Re: **BID ADDENDUM No. 2**
Phase 1A – Bond Improvements
Bedford Central School District
SED No. 66-01-02-06-0-003-021 (FLHS)
SED No. 66-01-02-06-0-007-011 (FLMS)
SED No. 66-01-02-06-0-006-015 (MKES)
SED No. 66-01-02-06-0-002-016 (BVES)
SED No. 66-01-02-06-0-004-020 (BHES)
SED No. 66-01-02-06-0-009-014 (WPES)
SED No. 66-01-02-06-0-001-016 (PRES)
BBS File No 22-225A-G

The following changes shall be and are hereby made:

A2.01 MKES

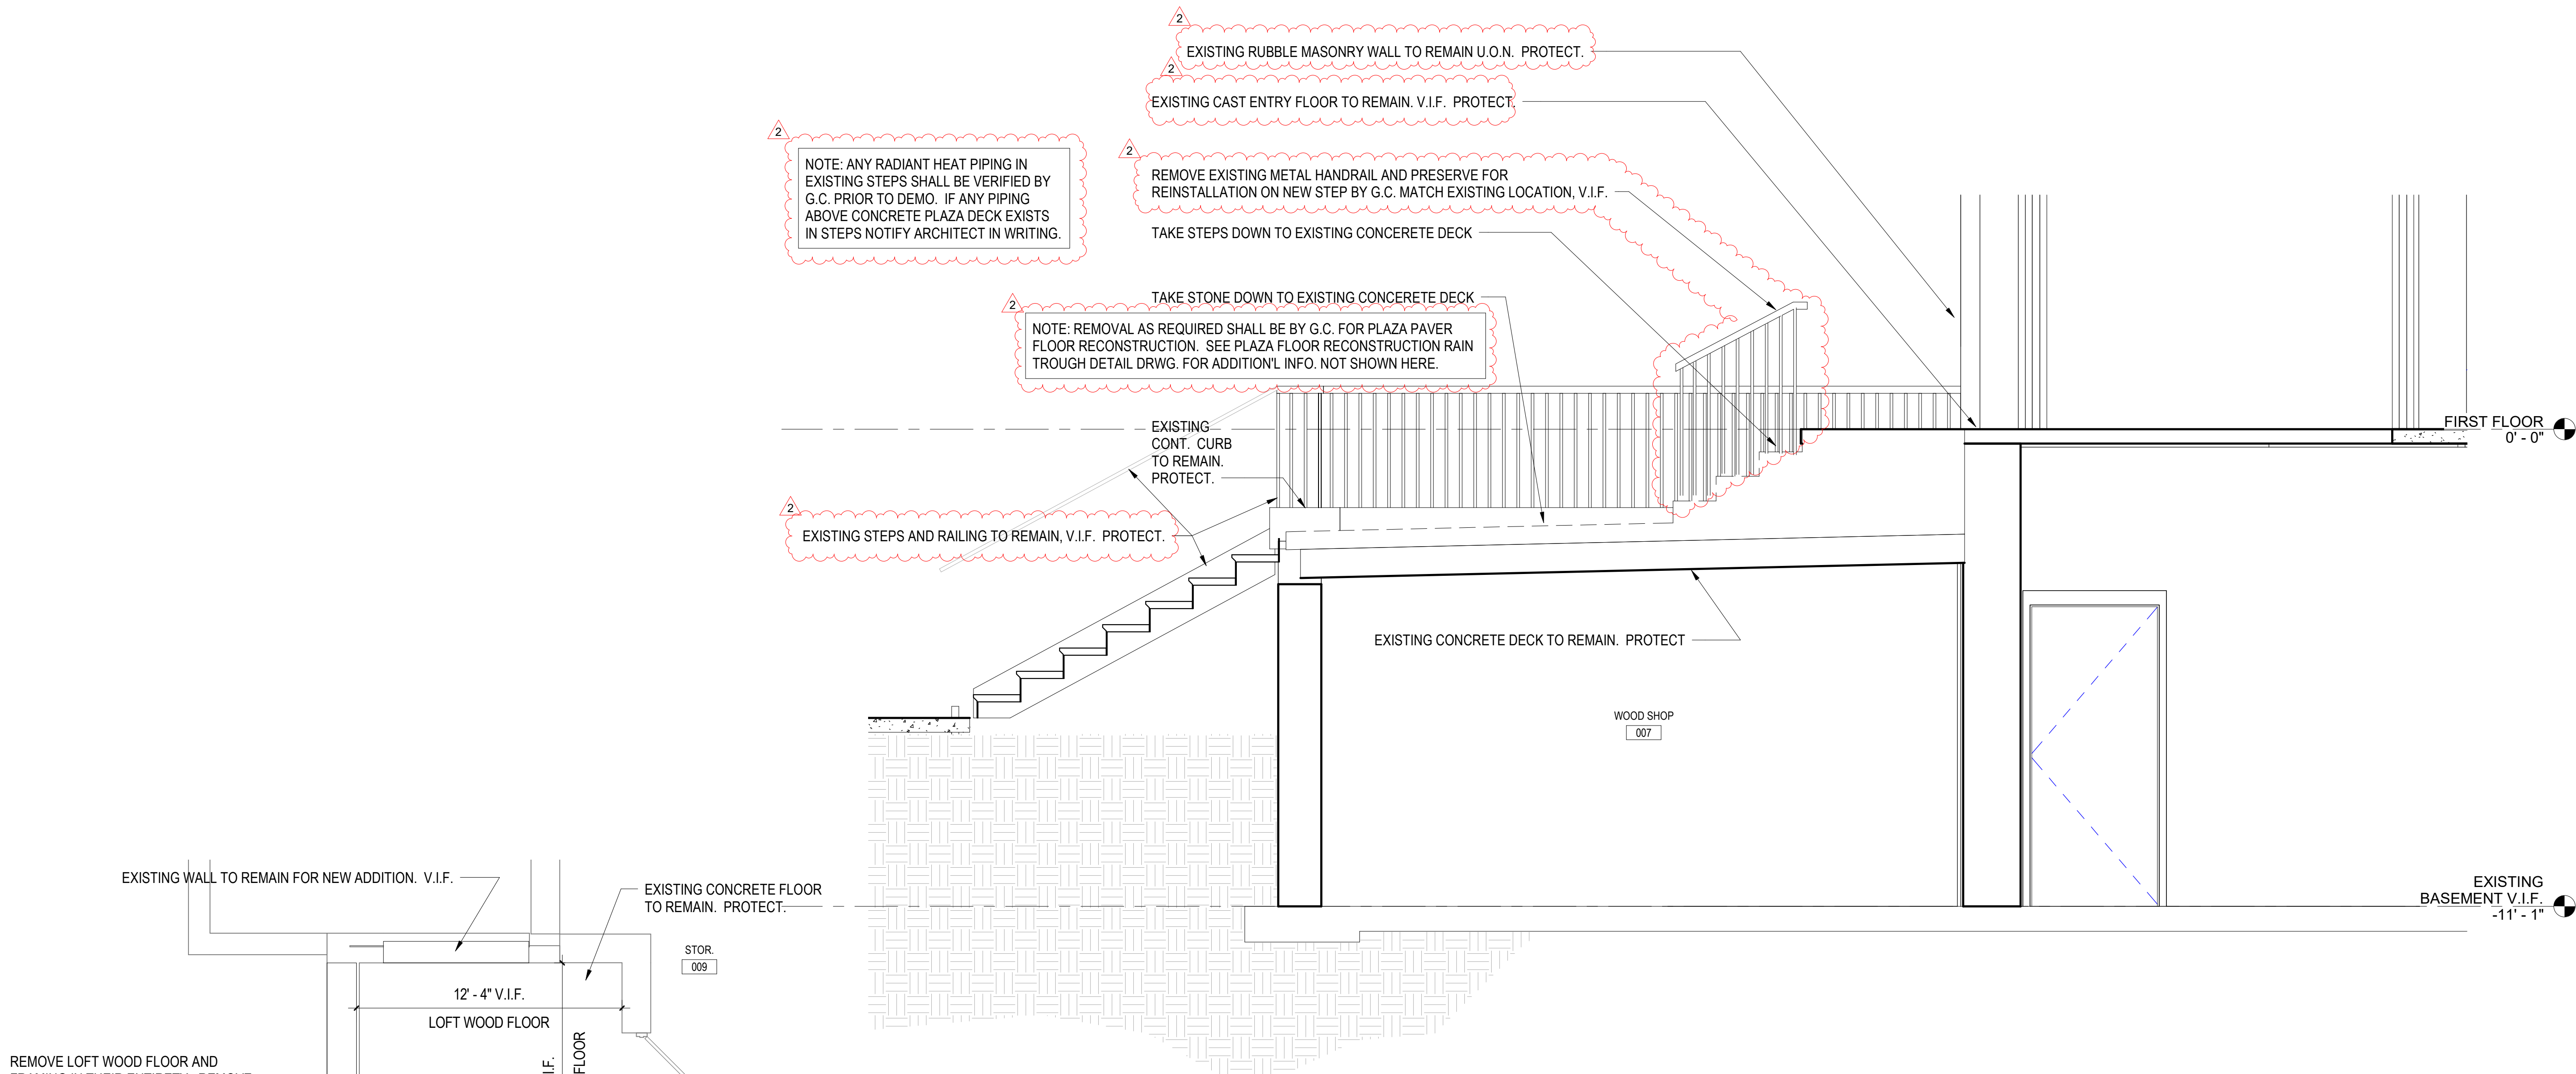
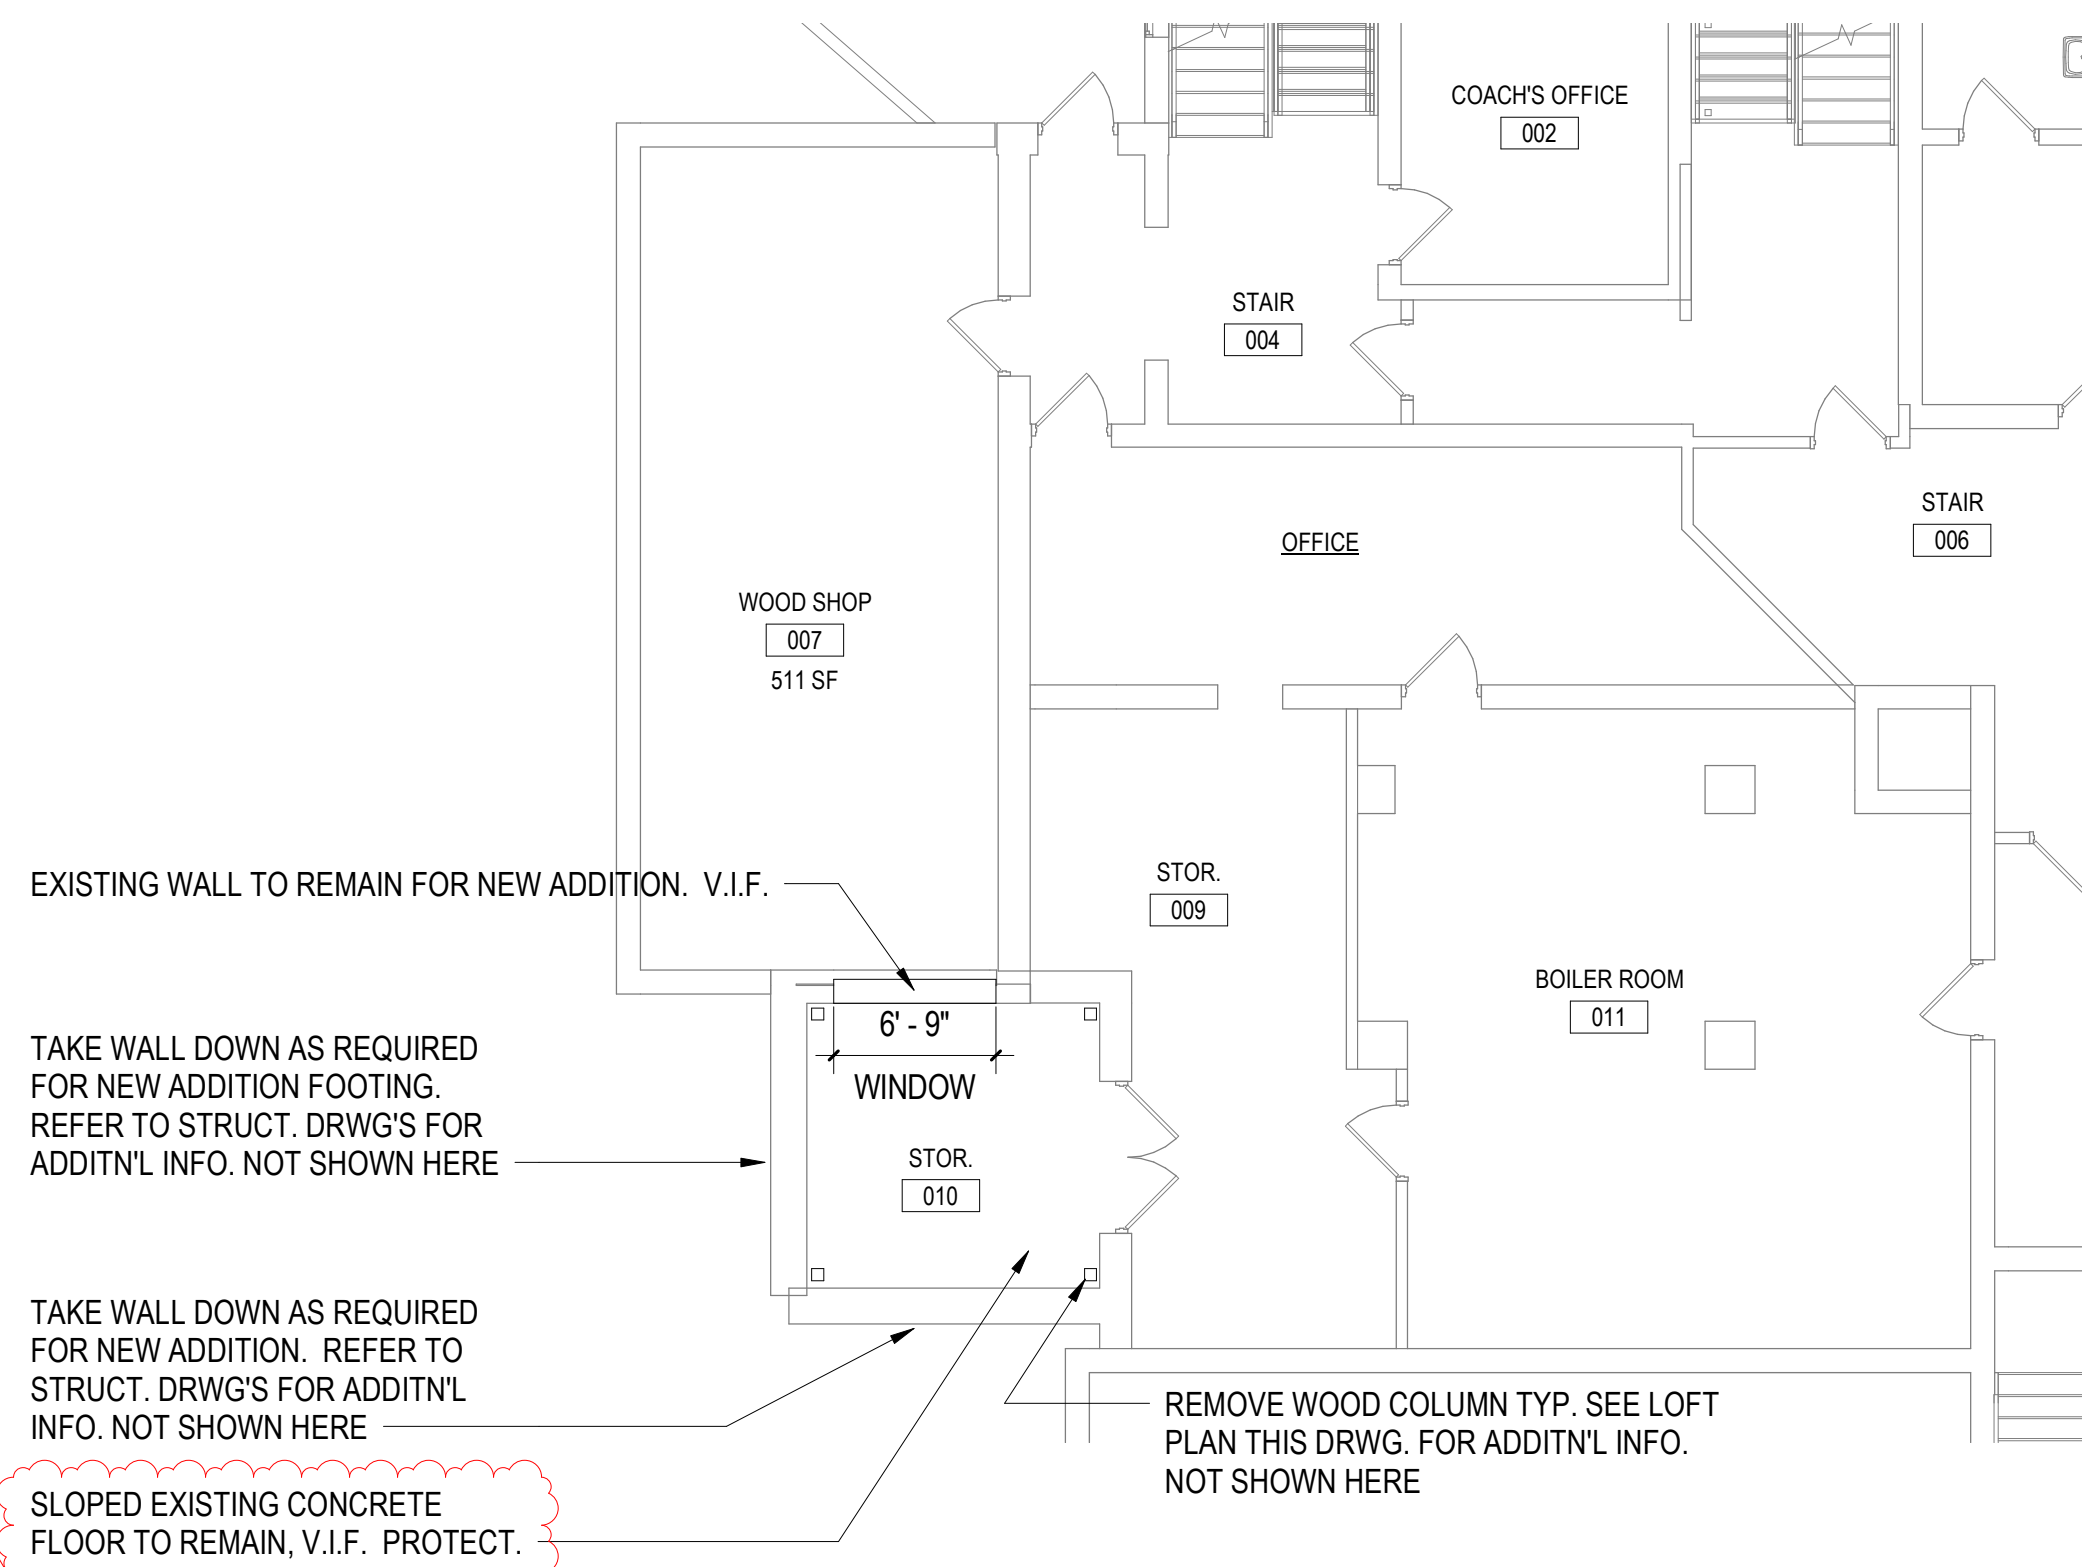
Drawing A1.01 MKES, section 3 notes existing drywall ceiling and VCT floor to remain and protect. Drawing A2.01 MKES, section 1 and 3 shows new ACT drop ceiling and LVT/VCT/T1 floor finishes. Please confirm existing ceiling and walls remain and new finishes installed over existing.

BBS Response: Refer to revised drawing.
